APPENDIX U
Hydrology
Technical Memorandum

MEMORANDUM

Subject: Hydrology Technical Memorandum – JVR Energy Project

Public comments were received on the JVR Energy Park Draft Environmental Impact Report (EIR) regarding hydrology. This technical memorandum provides information regarding issues raised in the comments, including the photovoltaic (PV) panel height and Proposed Project impervious surfaces.

FIGURE KH-EIR-PR-02

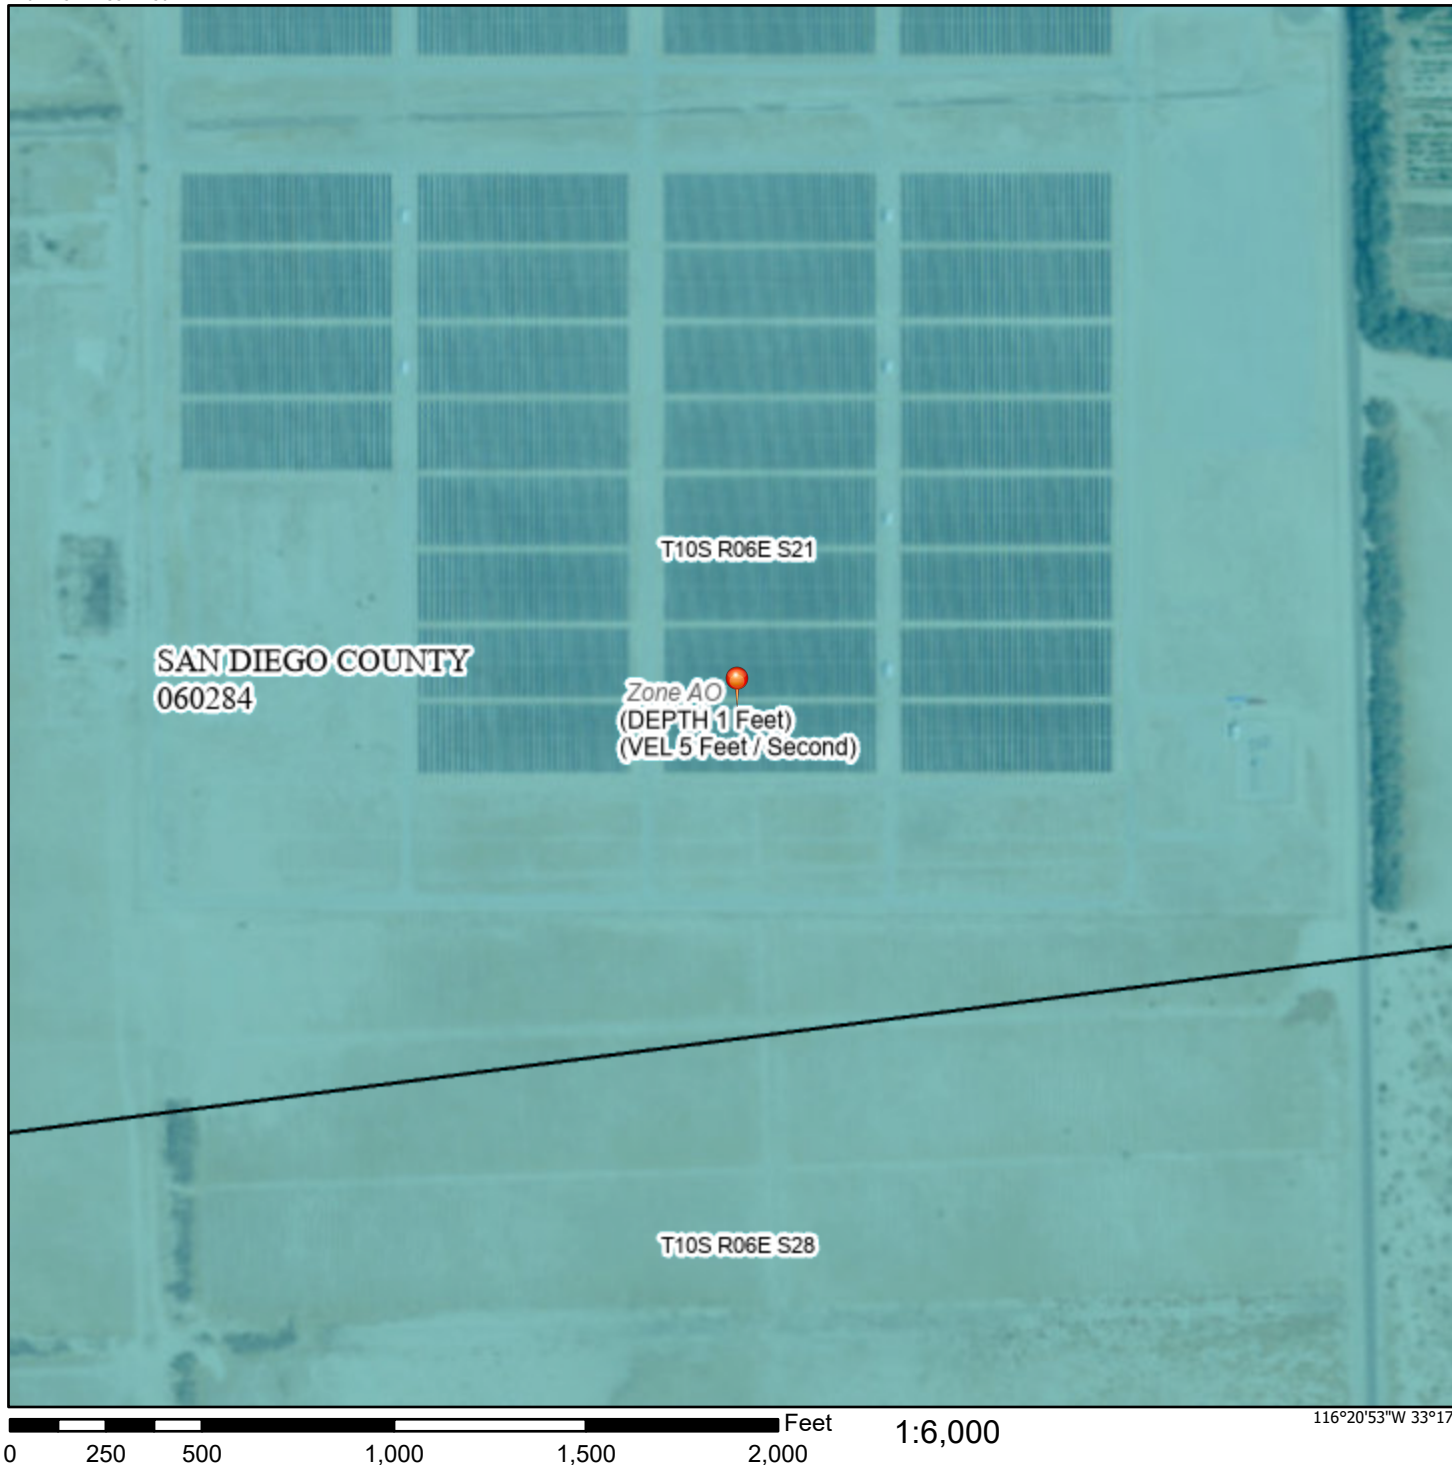
Additionally, a commenter draws comparison to an existing solar facility referred to as “Borrego Solar Farm” located in San Diego County as having highest points of 6 to 8 feet above grade and requests an explanation of why such heights cannot be used on the Proposed Project. Kimley-Horn assumes this is referring to the facility permitted through the County under MUP 3300-10-026, EIR No. 3910-10-050-001 and built in 2013 by NRG. The Borrego facility is located in unincorporated San Diego County just north of Borrego Springs, southwest of the intersection of Borrego Valley Road and Henderson Canyon Road, about 45 miles north of the Proposed Project. Although both the Borrego facility and the Proposed Project will use Single-Axis-Tracker (SAT) racking systems, these three main differences between the two facilities can explain the discrepancy in max panel heights:

- 2) Flood Depths: The Borrego site has less upstream offsite tributary area that discharges storm runoff onto the site where FEMA has estimated flood depths to be about one foot per Figure KH-EIR-PR-02. By contrast, the Proposed Project site that has over 100 square miles of tributary watershed area concentrating and draining through it, generating flood depths up to five feet with no feasible diversion or containment options to prevent that run-on from impacting the PV array field and forcing the design to raise equipment.
